# Modulators and Isolators for Advanced LIGO

UF LIGO group

28 April 2006

- EOMs
  - » RTP as EO material
  - » RTP has significantly lower absorption and therefore thermal lensing.
  - » Use "industry standard" housing, so can be replaced in existing hardware.
- FI
  - » Uses two TGG crystals/ quartz rotator to cancel thermally induced birefringence
  - » Uses DKDP, a  $-dn/dT$  material, to compensate thermal lensing.
- Performance data and implementation issues presented in “Upgrading the Input Optics for High Power Operation”
- This review tries to answer questions posed by the review panel

### Thermal lensing of RTP

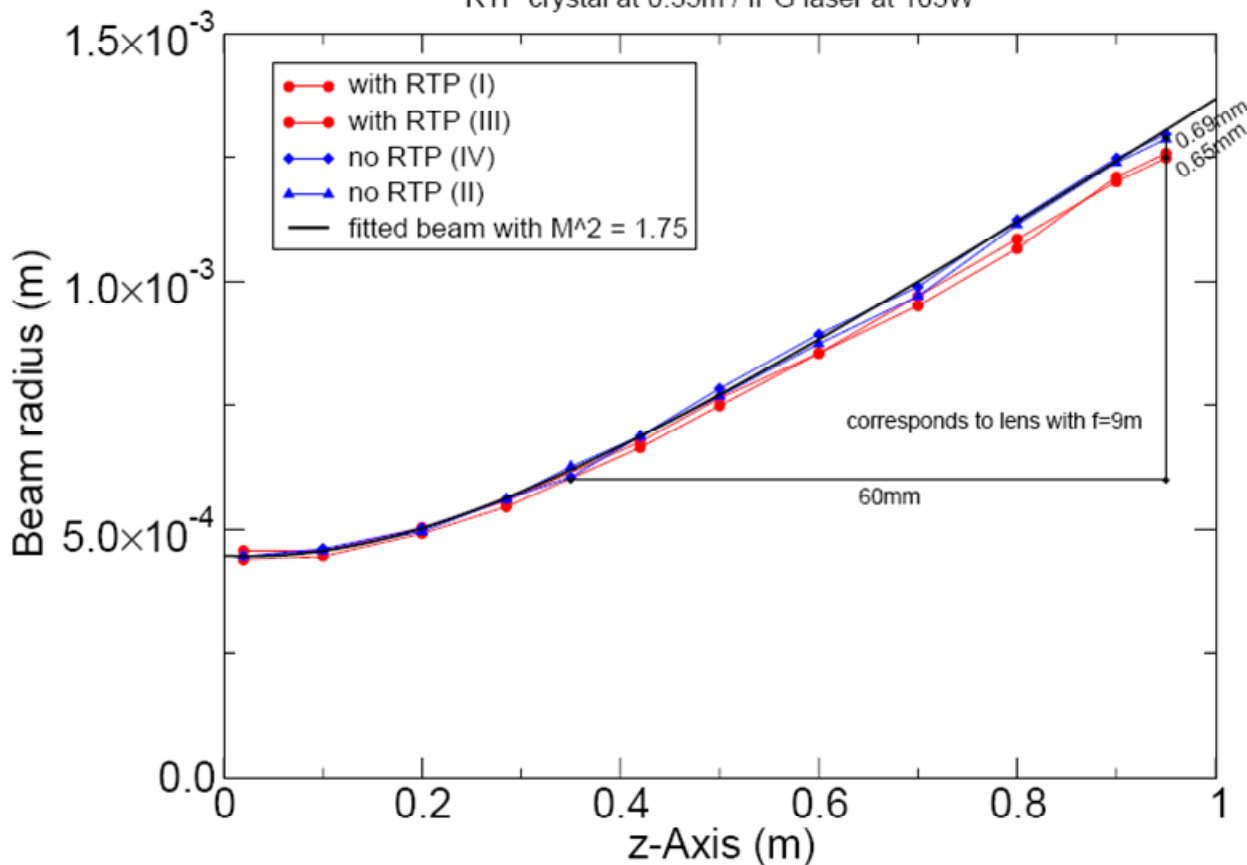
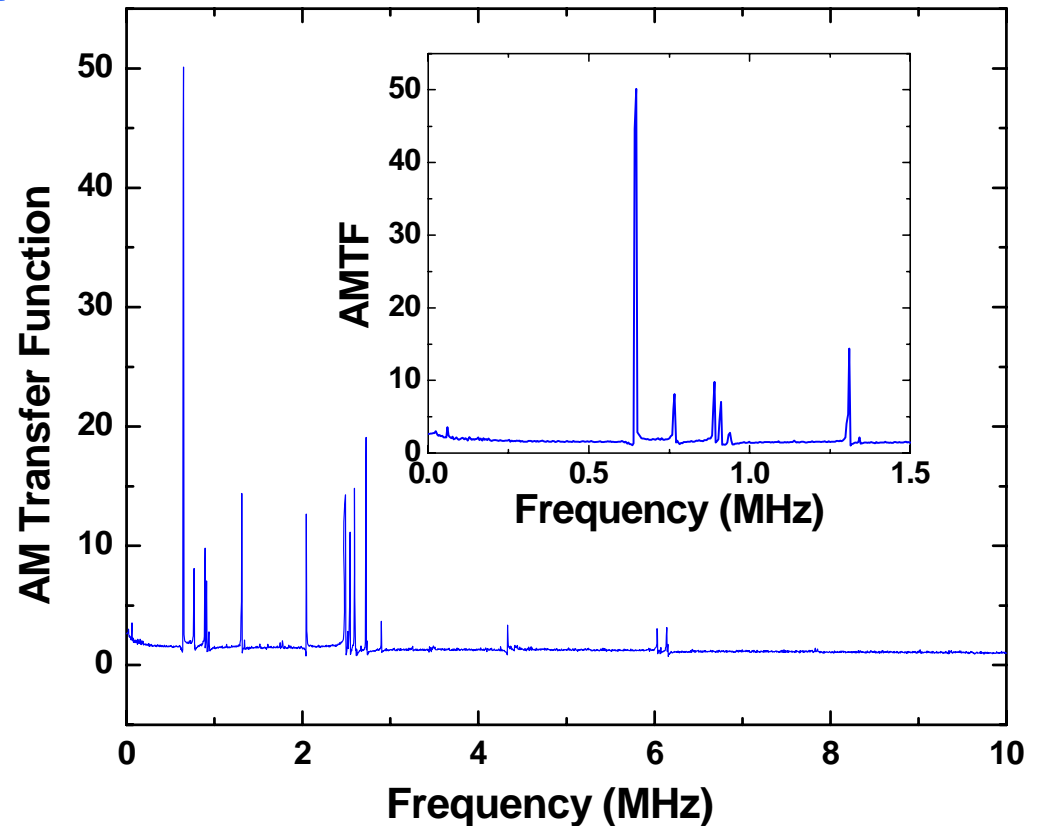
- Section 1.2.5 says that no thermal lensing was seen up to 60 W. What is the upper limit on alpha, or on the focal length, that can be established with this data?

- Thermal lensing scales as the parameter  $Q \quad Q \equiv \frac{dn}{dT} \frac{\alpha}{\kappa}$

- RTP has  $Q$  30—50 times smaller than  $\text{LiNbO}_3$
- Can estimate thermal lens of  $f \sim 20$  m
- Measured a  $f \sim 9$  m thermal lens at 103 W power
- Corresponds to a  $\sim 5$  m thermal focal length when scaled to 180 W.
  - » compare with  $\text{LiNbO}_3$  (20 mm long):  $f_{\text{thermal}} \sim 3.3$  m @ 10 W

thermal lens will scale  
inversely with crystal  
length

eom\_assembly.easm

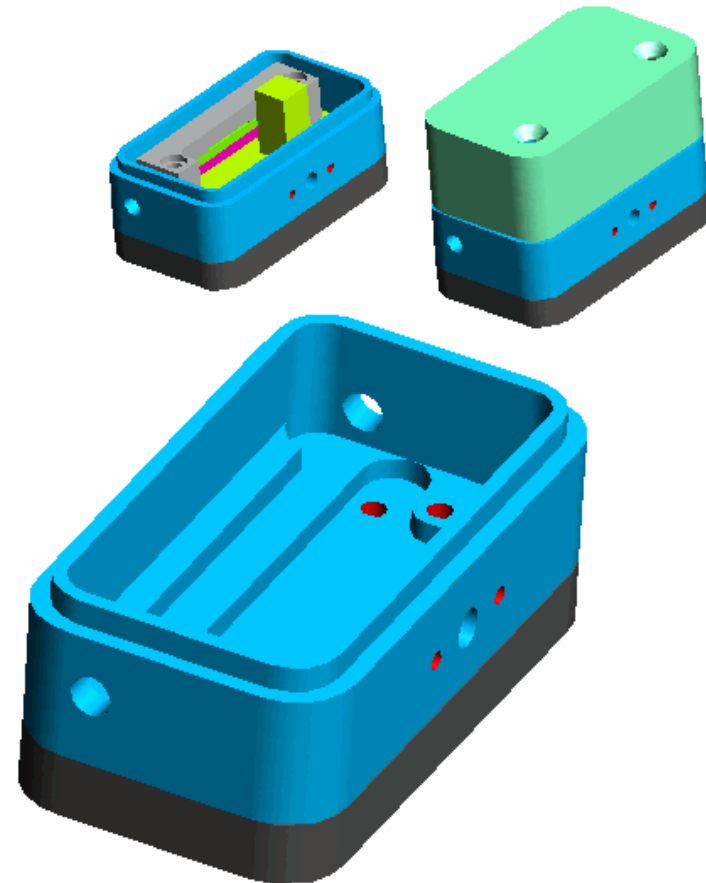
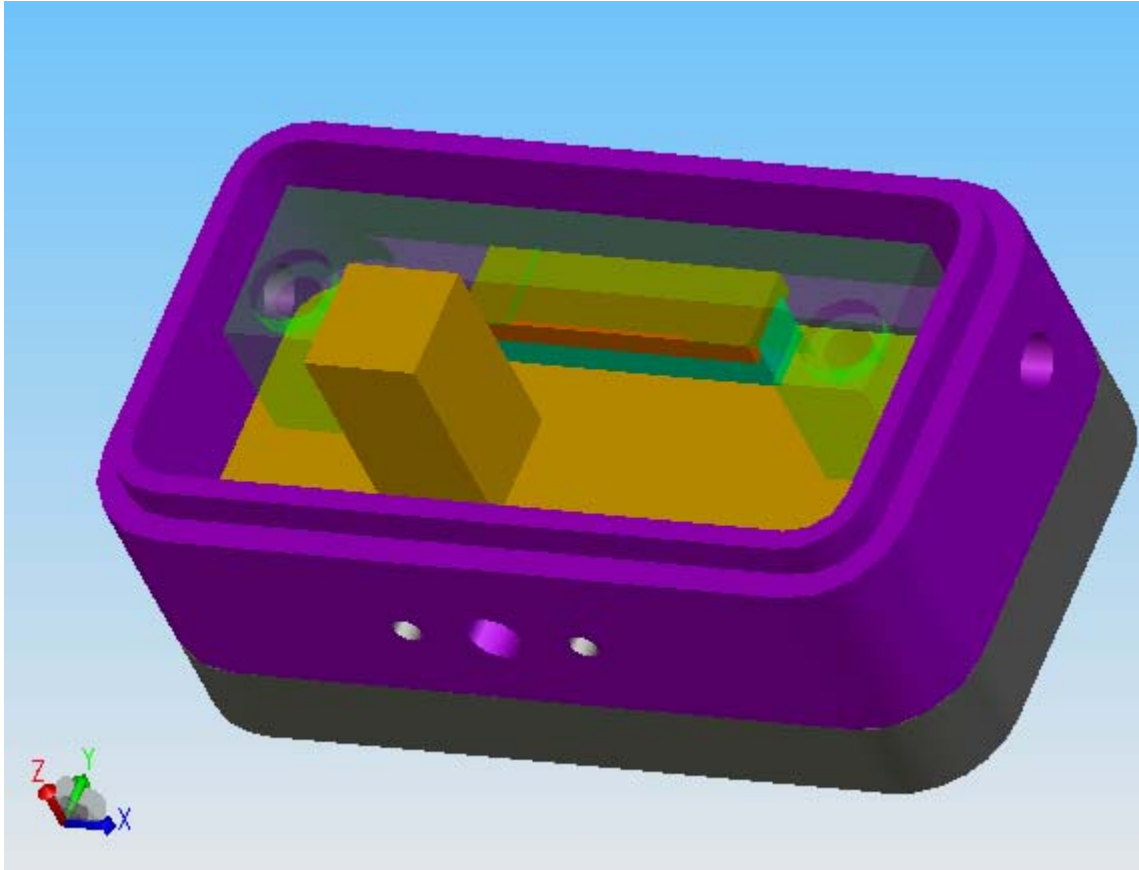
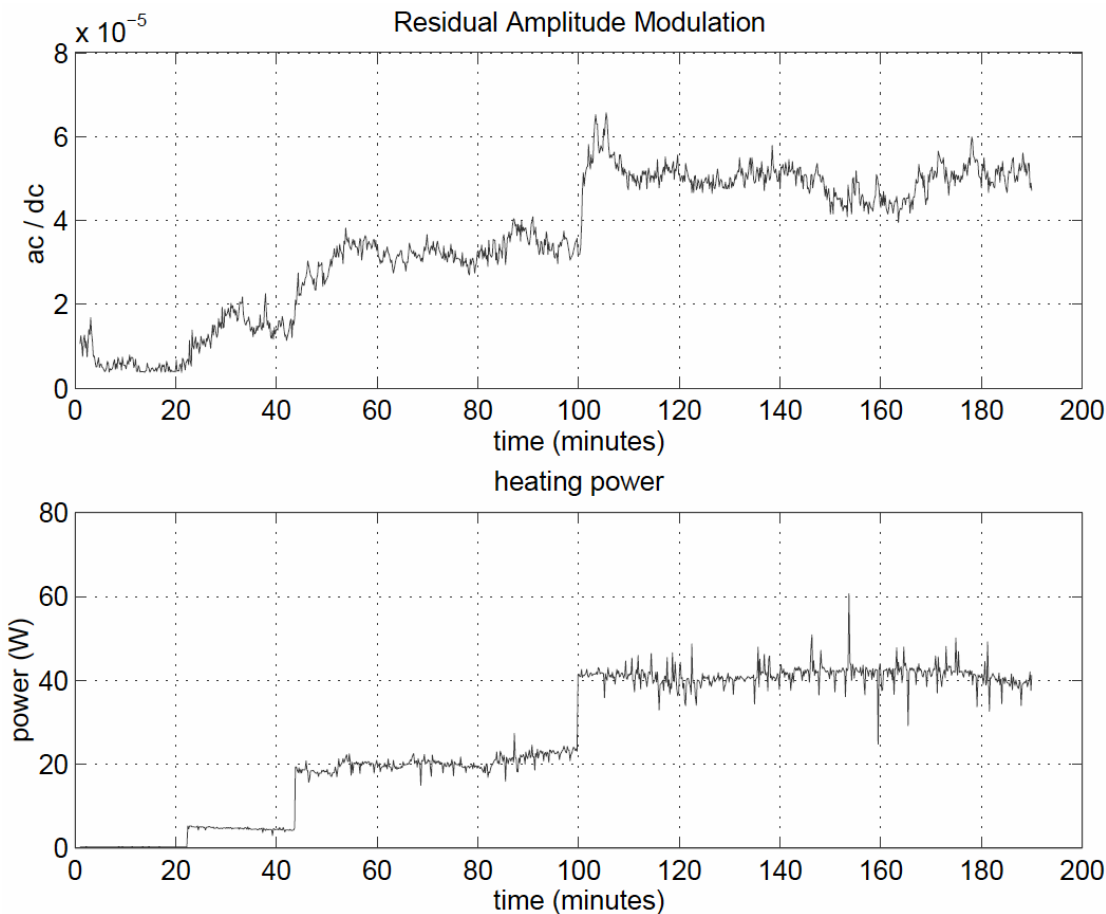
- “How is the crystal mounted in the box? How big is the aperture in the housing? What thought went into choosing the (Al) housing material?”
- 1.5 cm x 0.4 cm x 0.4 cm crystal
- Electrodes: gold over titanium
- Industry-standard housing
  - » New Focus reverse-engineered
- Cover and can made of aluminum
  - » durable and easy to machine.
  - » Other materials are possible.
- The base is made of delrin.

RFAM of Resonant Sideband

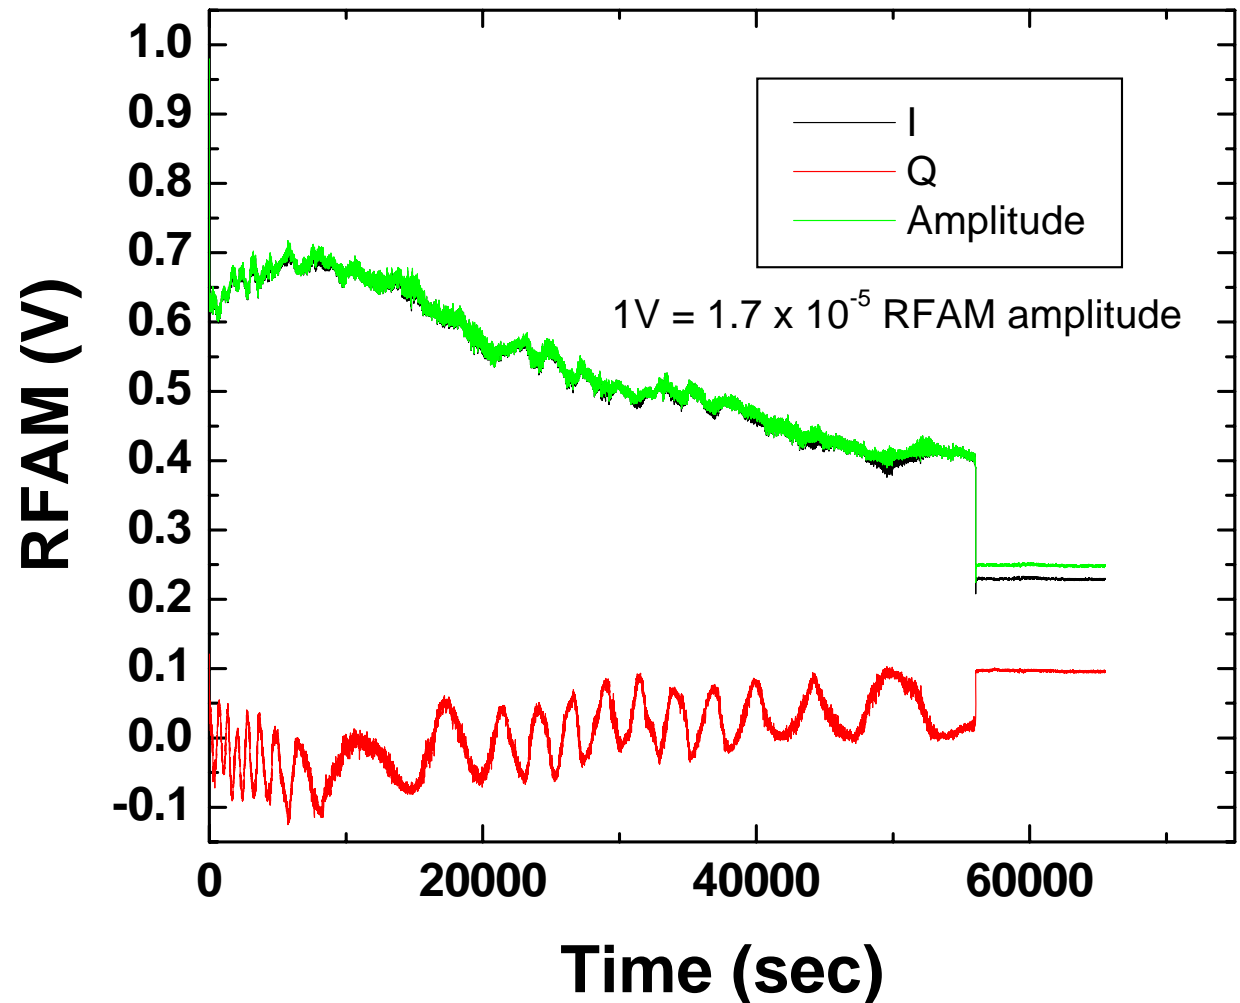
- “Would like to see a measurement of the dynamic RFAM, with comparison to the current LiNbO3 modulators.”

- Measured RFAM in RTP EOMs vs laser heating power
- ‘Static RFAM’ measured over 20 min period
  - $\Delta I_{\Omega_{mod}} / I_{DC} \sim 10^{-5}$  @  $\Omega_{mod} = 19.7$  MHz
- (No attempt to correct and re-establish baseline upon heating)

# LIGO RFAM in $\nu$ Focus LiNbO<sub>3</sub> EOMs

- data from LLO PSL enclosure, Oct. 2000

- $\Delta I_{mod} / I_{DC} \approx 7 \times 10^{-6}$   
(Better now?)

- Comparison:

- LIGO1 EOMs somewhat better

- Possibly due to the lack of wedges on the crystal on RTP

- or temperature conditions

- could investigate temperature-stabilized EOMs

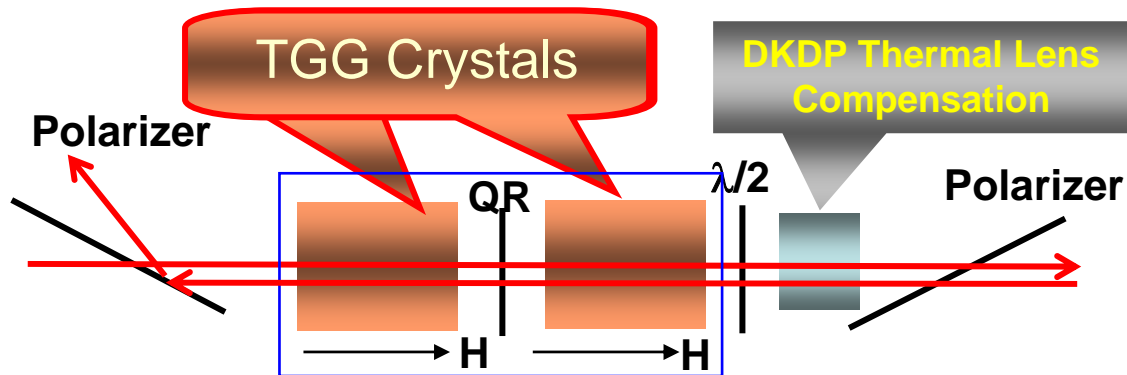
- “Need to discuss the different options of driving & impedance matching to the crystal:
  - » - single electrode vs multi-electrodes on the crystal
  - » matching circuit components: inside vs outside the crystal housing”
- - some progress toward a multiple frequency driver circuit, but more simulations and testing are needed before we feel confident that it will work.
- Matching circuits: for higher frequencies, better to put the matching circuit in the crystal housing
  - » Driving the cable at high frequencies is difficult
- possible to get crystals as long as 40 mm
  - » could put three electrodes (one for each frequency) on a single crystal.
  - » Some thought would need to be put into defining the gap spacing and estimating the effects of fringing fields between the gaps.

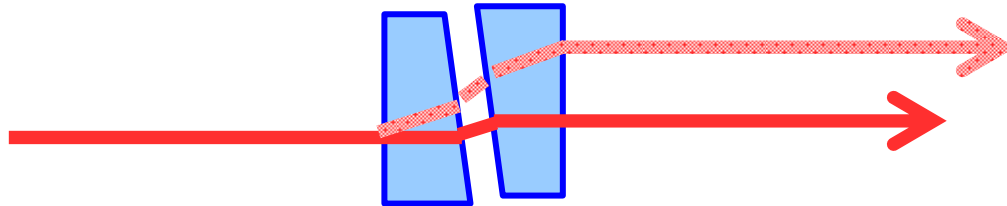
- “Thermal beam drift/steering: the limit of  $100 \mu\text{rad}$  seems too high, it's a large fraction of the beam divergence angle -- and we'd prefer not to have to use the RBS to compensate for it. Can we make it more like  $<10\%$  of the beam divergence angle, which would be around  $20 \mu\text{rad}$ ?”
- iLIGO upgrade (upper limit of 30 W through the FI)

- Calcite:  $40 \mu\text{rad}$  @ 30 W; TFPs:  $3 \mu\text{rad}$  @ 30W

- Scaling to AdvLIGO ( $\sim 150$  W)
  - » Calcite:  $200 \mu\text{rad}$
  - » TFPs:  $15 \mu\text{rad}$
- Calcite potentially problematic for AdvLIGO
  - » Could think about using double wedges for compensation, but beam separation may be a problem

- We recommend TFPs, and are working with ATF to develop special high extinction ratio coatings (10000:1)

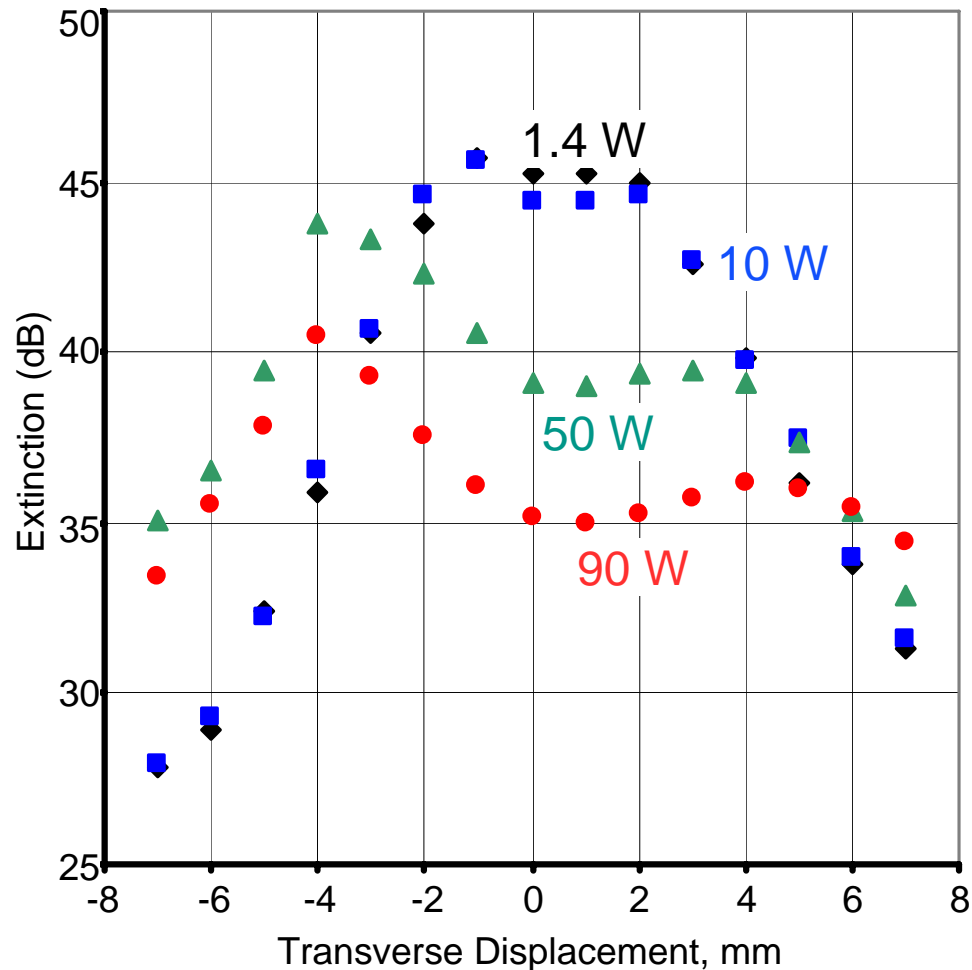
- “What is the assumed and/or optimum spot size in the Faraday?”
- characterization measurements were performed with a beam size of  $\sim 1.9$  mm
  - » Beam in iLIGO is 1.6 mm – 1.8 mm
  - » Beam in AdvLIGO is 2.1 mm
- Thermal effects are first order insensitive to beam size
- In general, smaller is better to sample homogeneous magnetic field

Power Budget: TFP FI

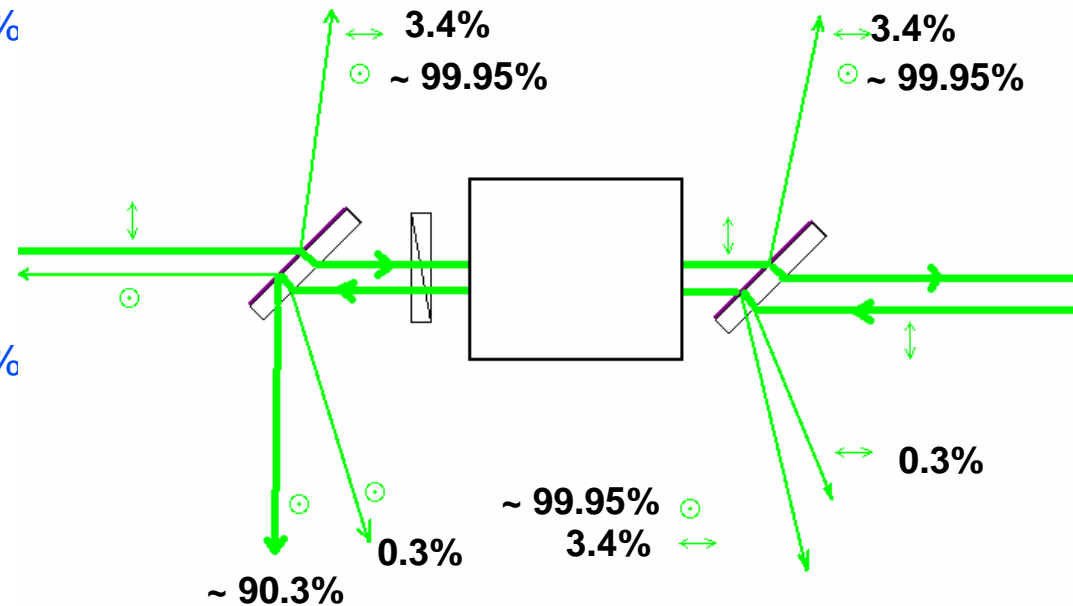
- “Where is the power going (for both the transmitted and rejected cases)? Are all the beams being sufficiently dumped?”
- FI with TFPs:
  - » Percent transmitted: 93.3% +/- 0.3%
  - » Percent rejected: 90.3% +/- 0.3%
- FI with calcite wedge polarizers:
  - » Percent transmitted: 98.3% +/- 0.3%
  - » Percent rejected: 94.6% +/- 1.0%
- Most or all of the beams from polarizers will be picked off and sent through viewports for diagnostic purposes

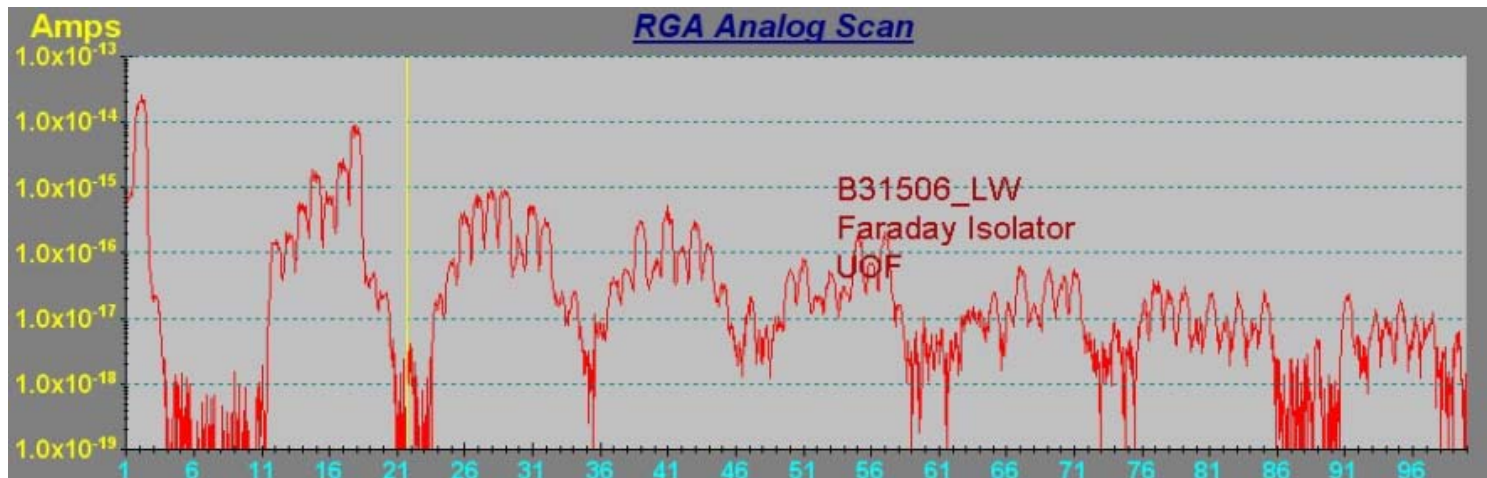
- Thermal performance in vacuum: Has there been any analysis of this? Any problems foreseen?
- Maximum absorbed power is  $P \sim 1.5$  W in TGG for AdvLIGO
  - » Concern about long term heating of magnet
  - » Assuming all heat is radiated, the temperature is:

$$T = (P/\varepsilon\sigma A)^{1/4} = 30 \text{ C}$$

- Assume  $\varepsilon \sim 0.9$ ,  $\sigma$  = Wien's constant,  $A$ =TGG surface area
- This is somewhat conservative
  - TGG is thermal contact with rotator housing which is in good thermal contact with HAM tables

russian\_FR.easm

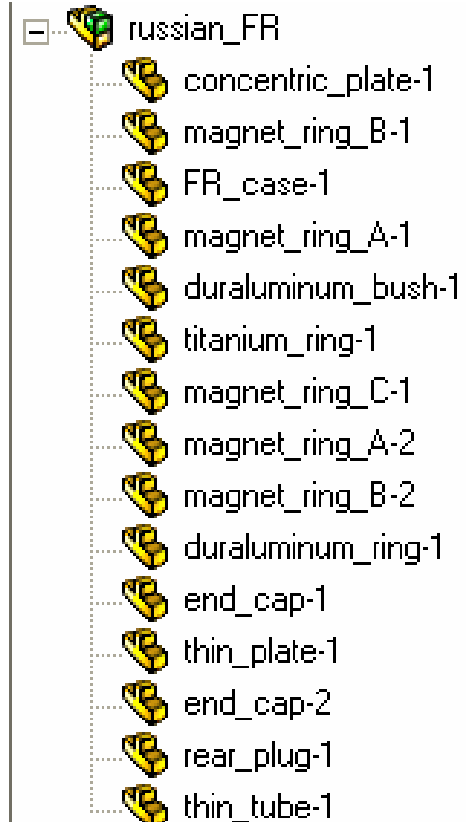
- “Would like to address vacuum compatibility. This seems to be not very mature at this time, and will need to be thoroughly reviewed before finalizing the design. Can we see a list of all components being used?”
- Prototype FR underwent bake out in March 2006
  - » All parts but optics baked at 60 C for 48 hours
    - Magnet: sintered NiFeB
    - Housing: aluminum with one titanium part
  - » Failed miserably...

- ... But this was not an unexpected result
  - » Prototype designed and assembled by IAP not for vacuum testing but for optical testing
    - Blind holes in design
    - Not assembled in LIGO 'clean' environment
- Housing undergoing redesign by UF to address vacuum issues
- Vacuum compatible version will be first baked and then assembled in clean conditions
  - » in optics labs at one of the sites (during an S5 break)
  - » Ready by late summer
